**Re: 770 Brookfield Road – On-Street Parking and Loading Assessment  
1<sup>st</sup> Review – Response to City Comments**

**Subject:** *770 Brookfield Road – On-Street Parking and Loading Assessment - Revised*

**770 Brookfield Road**

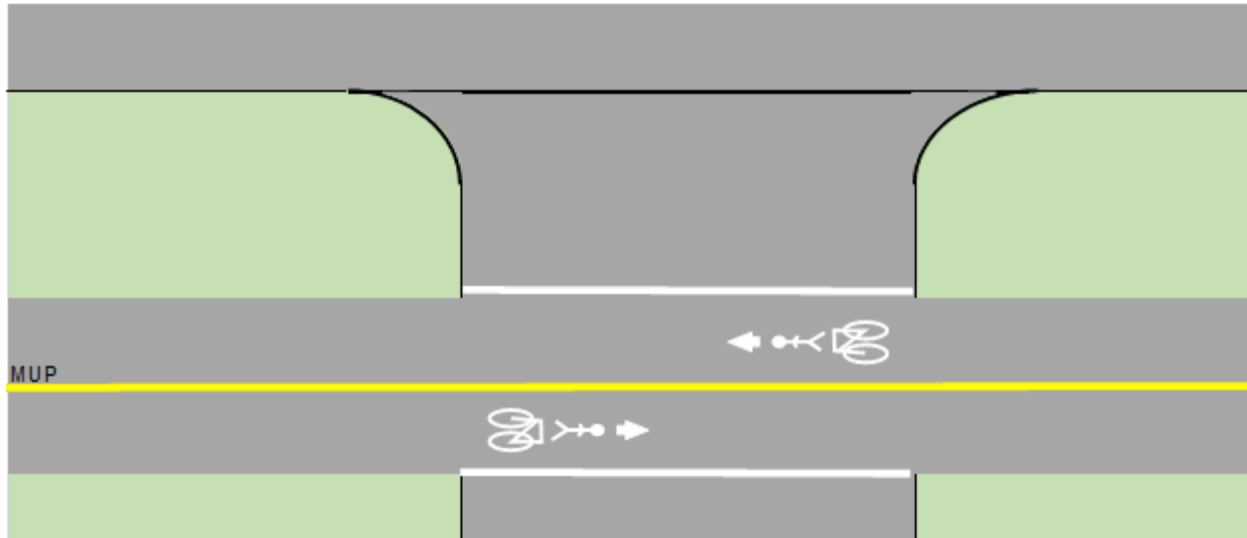
- Comment 10.** The existing multi-use pathway is missing pavement markings through the site accesses. Through this new pavement marking and signage plan, please add edge lines, centrelines, and stencils to the multi-use pathway within the site accesses. See schematic image below:  
Plan revised.

Figure 5: Proposed Brookfield Road On-Street Parking Arrangement

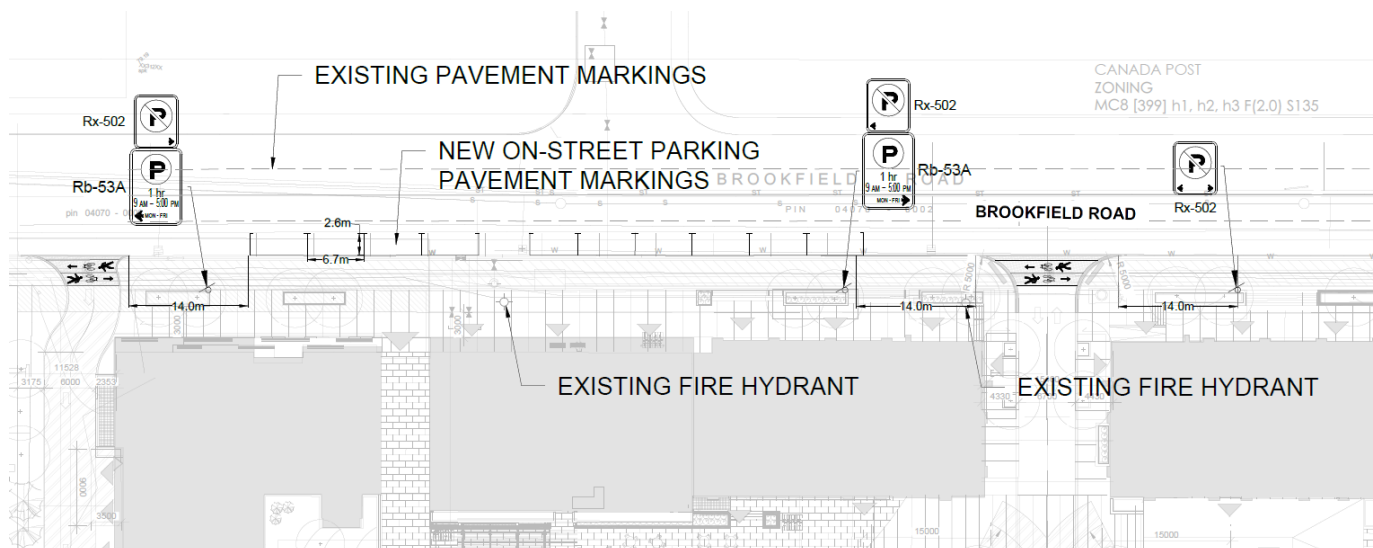
**Report updated. Point of curvature marked on plan.**
- Comment 4.** Regarding the fourth bullet of Section 4.0 and discussions of loading activities in Section 5.0, it should be noted that Section 4.6.5 of the City of Ottawa Official Plan reads as follows:  
*“Development shall minimize conflict between vehicles and pedestrians and improve the attractiveness of the public realm by internalizing all servicing, loading areas, mechanical equipment and utilities into the design of the building, and by accommodating space on the site for trees, where possible. Shared service areas, and accesses should be used to limit interruptions along sidewalks. Where underground parking is not viable, surface parking must be visually screened from the public realm.”*

Further, Brookfield Avenue is the boundary of “Hub” designation. Per Section 6.1.1 3) iii) of the Official Plan, “*development within a Hub shall establish buildings that place parking, loading, vehicle access, service entrances and similar facilities so as to minimize their impact on the public realm.*” Per Section 4.1.4 of the Official Plan, the City may review requirements for on-site loading and lay-by areas if requiring on-site loading would “*unduly [compromise] site functionality*”. However, ‘The Revalie Ottawa’ is not a small site, and therefore this does not apply. If the proponent wishes to reserve space for package deliveries, taxis, and loading and unloading, then they should consider signing/reserving on-site parking spaces for this purpose.

Noted. In discussions with the proponent, the loading facilities are no longer proposed on the street front. Deliveries and related loading/unloading activities are to remain on site.

478399 Dwg. No. 001  
Sheet 1 of 2

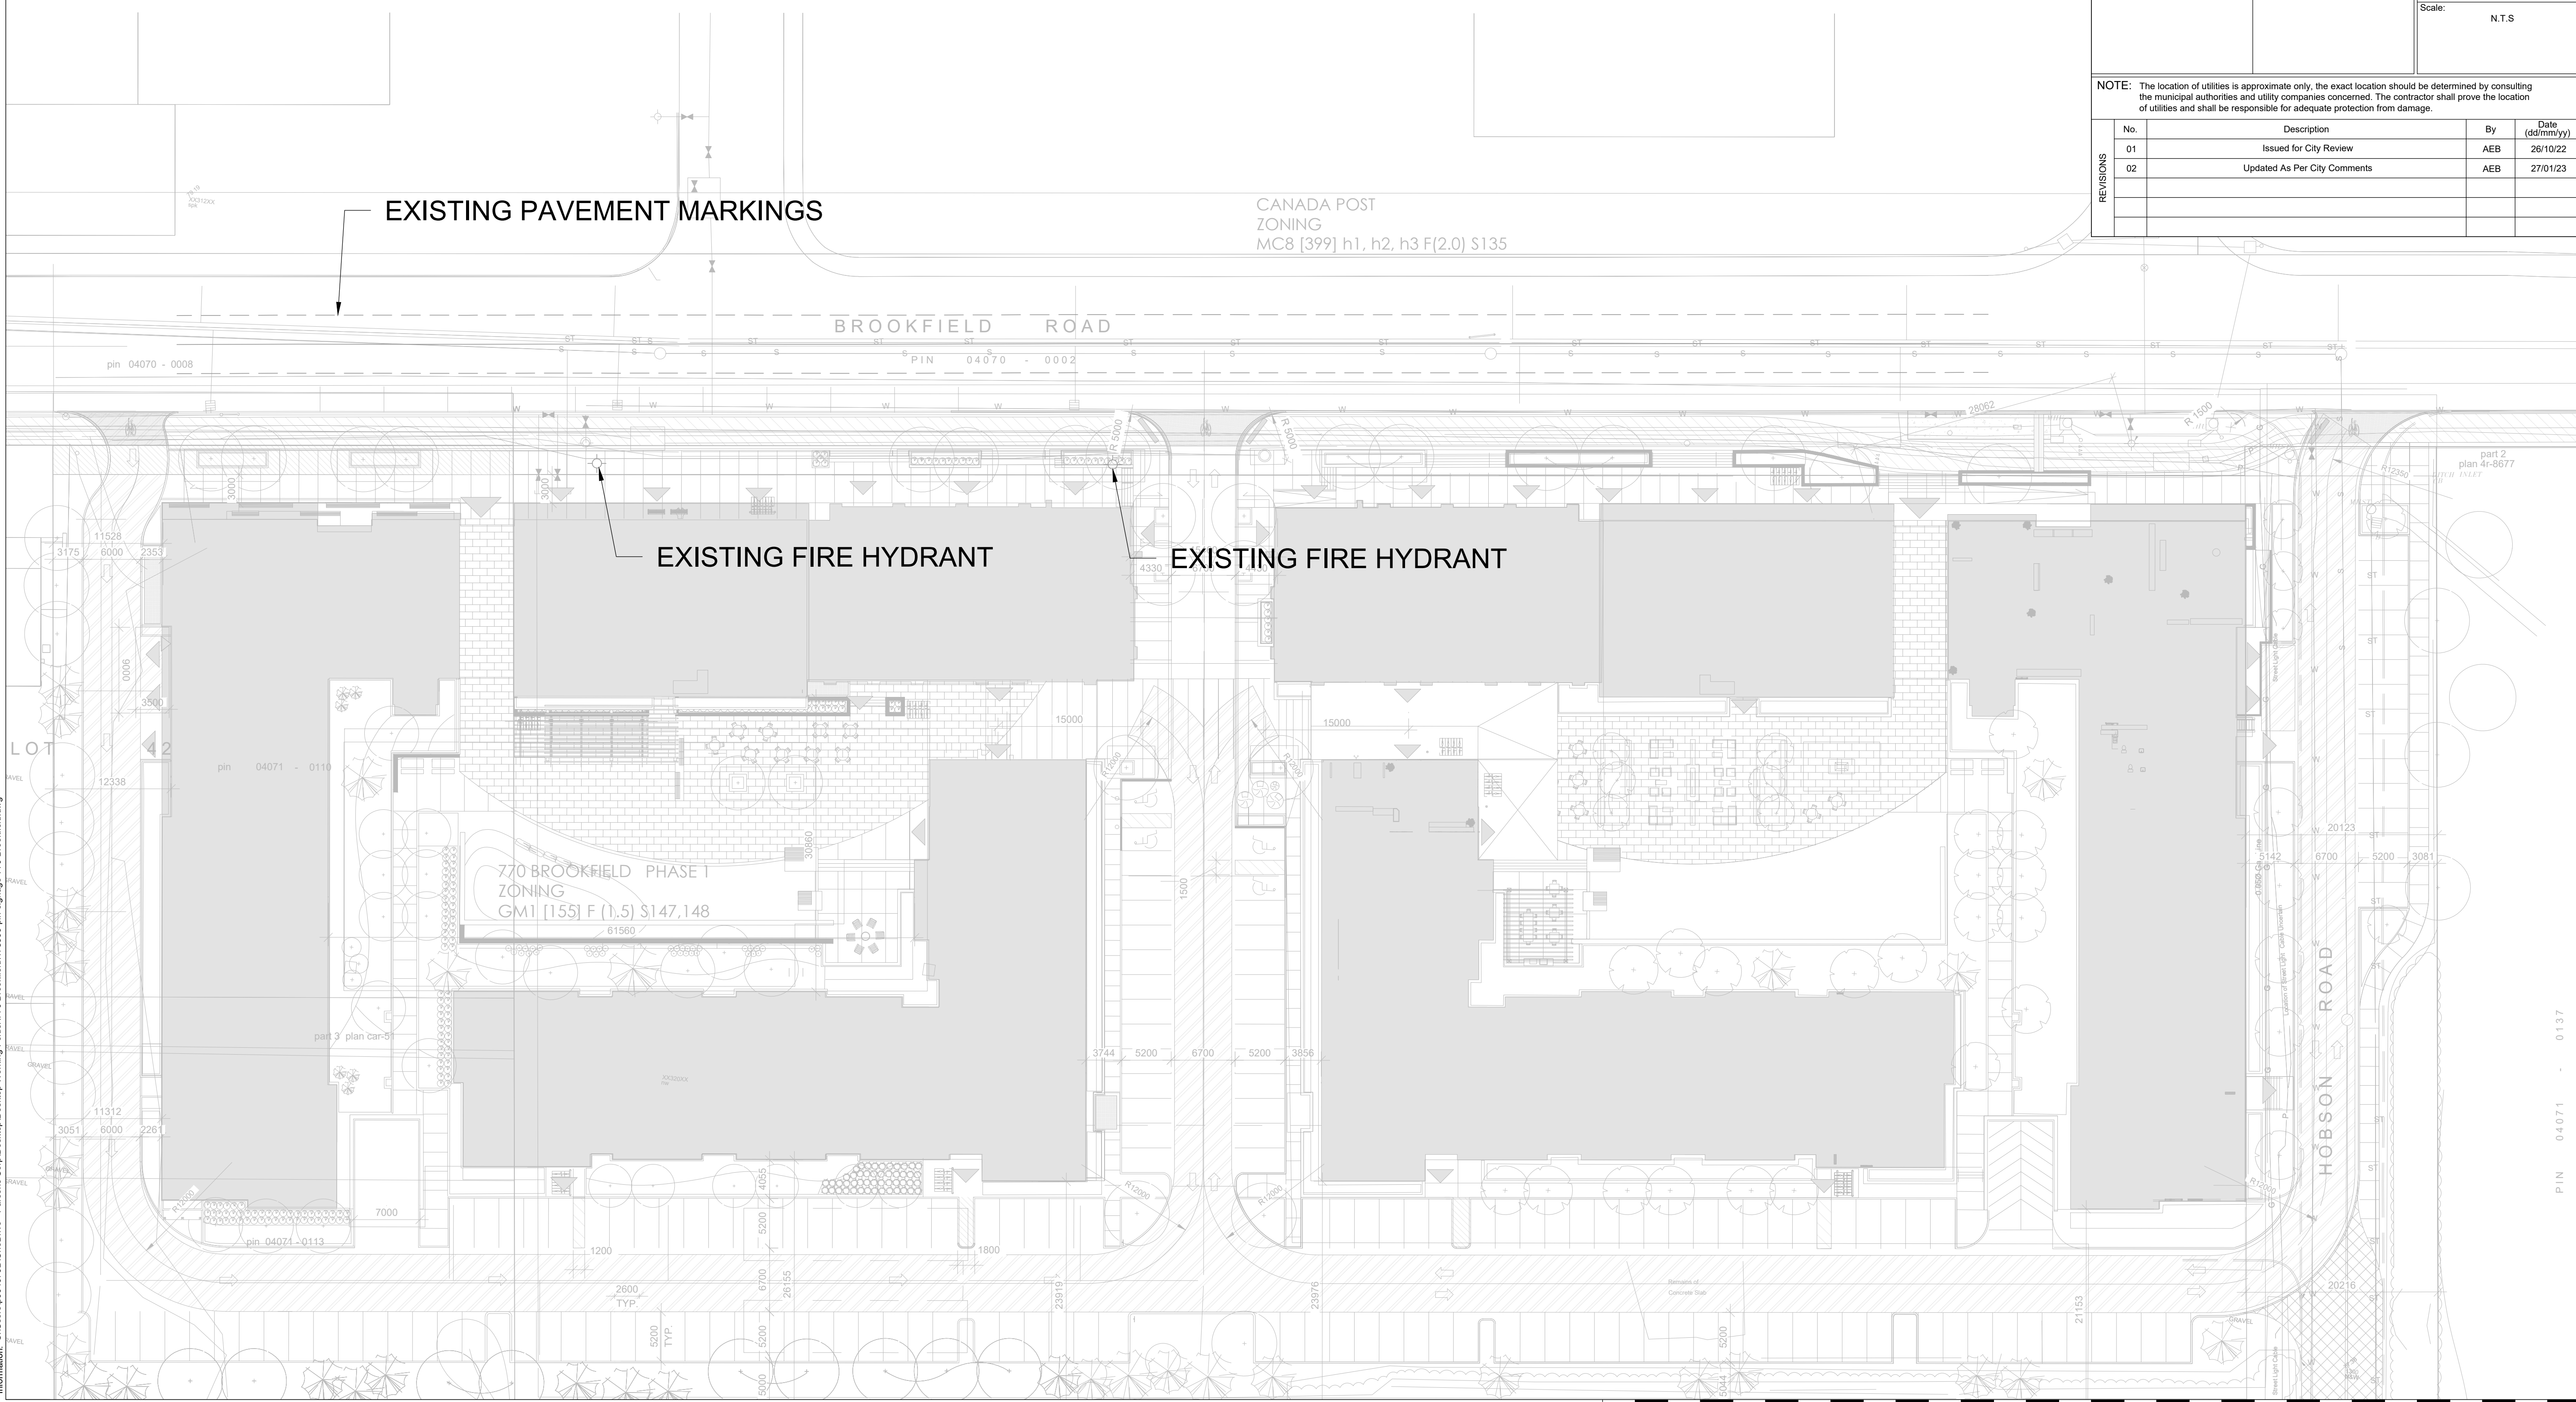
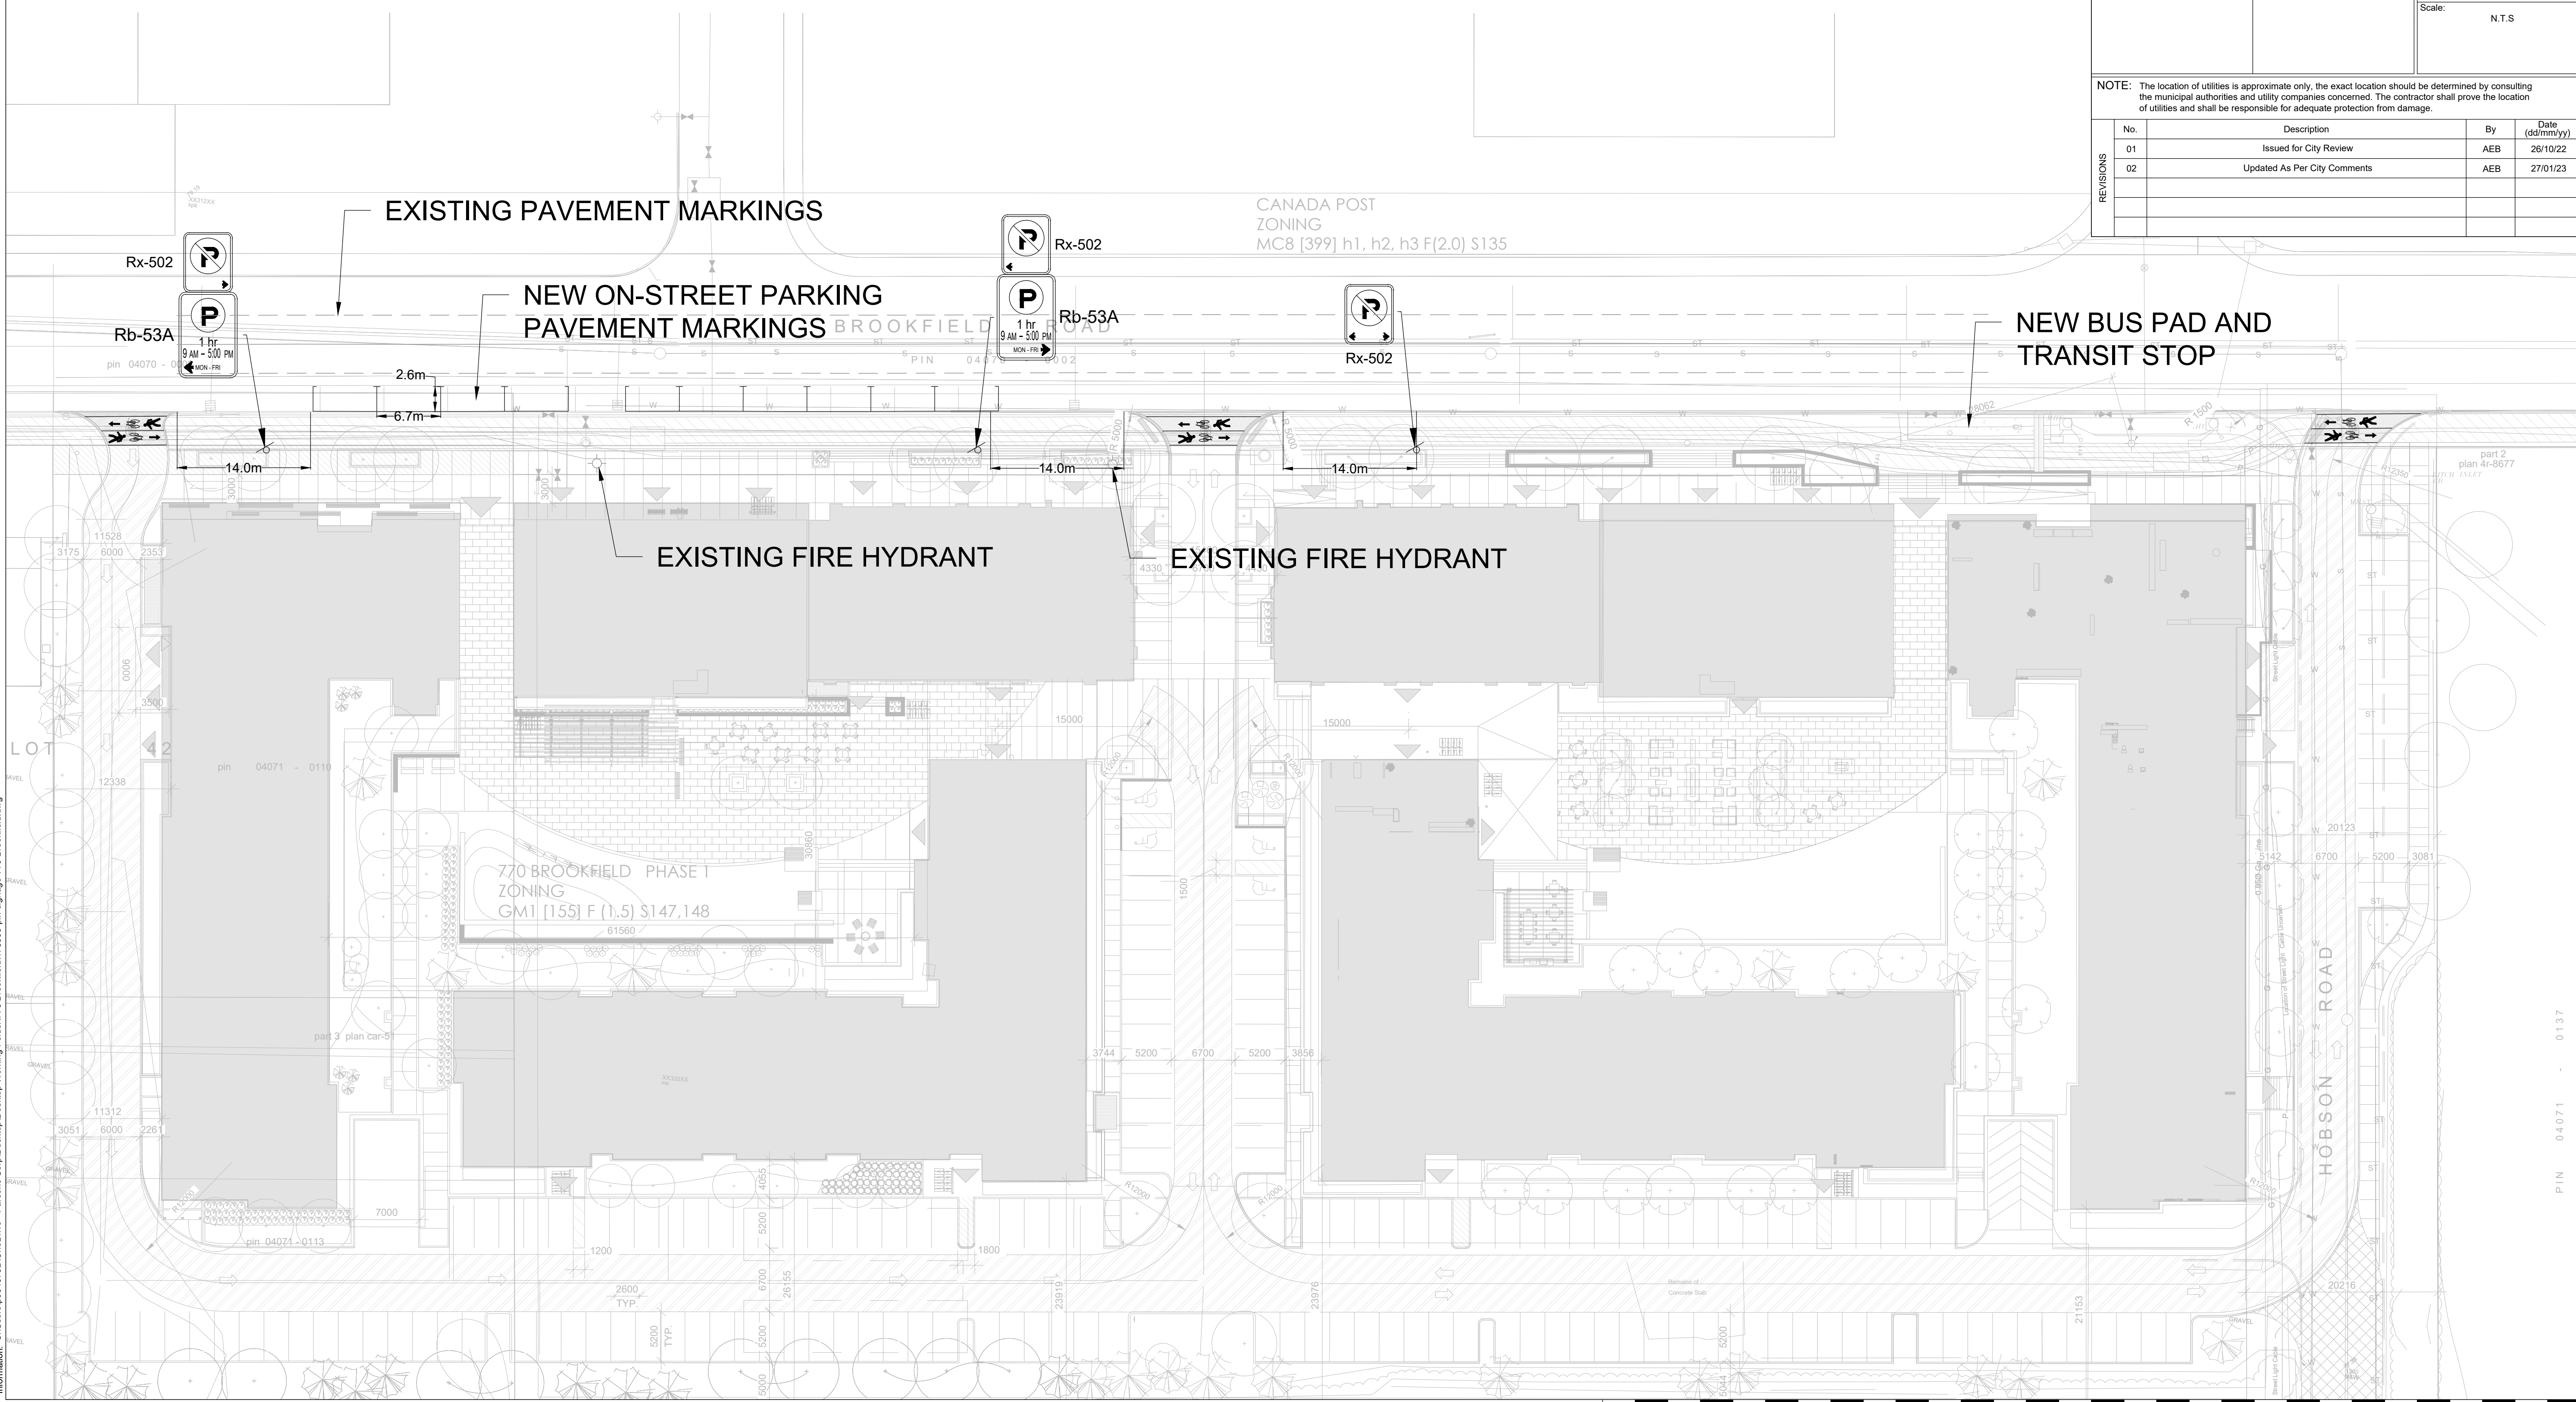
- Comment 5.** As noted, the proposed loading zones are not supported, and all Rx-521 signs should be replaced with Rb-53A signs.  
Plan revised.
- Comment 6.** Placement of signage west of the main access should be repositioned to a location that does not obstruct the staircases.  
Plan revised.

- Comment 7.** Placement of signage east of the main access is within the multi-use pathway. Per Section 4.3.5 of OTM Book 18, all signage should be installed 0.5m from the edge of the multi-use pathway (minimum 0.3m).  
Plan revised. Signage east of the access is intended to restrict parking nearest the adjacent OC Transpo stop.

- Comment 8.** Design of interaction between the multi-use pathway and the permanent location of OC Transpo stop ID: 4139 must meet Transit Services requirements.  
An on-site and virtual meeting was held with OCT to resolve the MUP-transit interaction. Plan revised.

- Comment 9.** As noted above, a minimum clear sight distance of 14m is required on either side of the site accesses. The 14m clear sight distance should be measured from the point of curvature of the curb return. Dimension this distance in the signage plan.  
Plan revised.
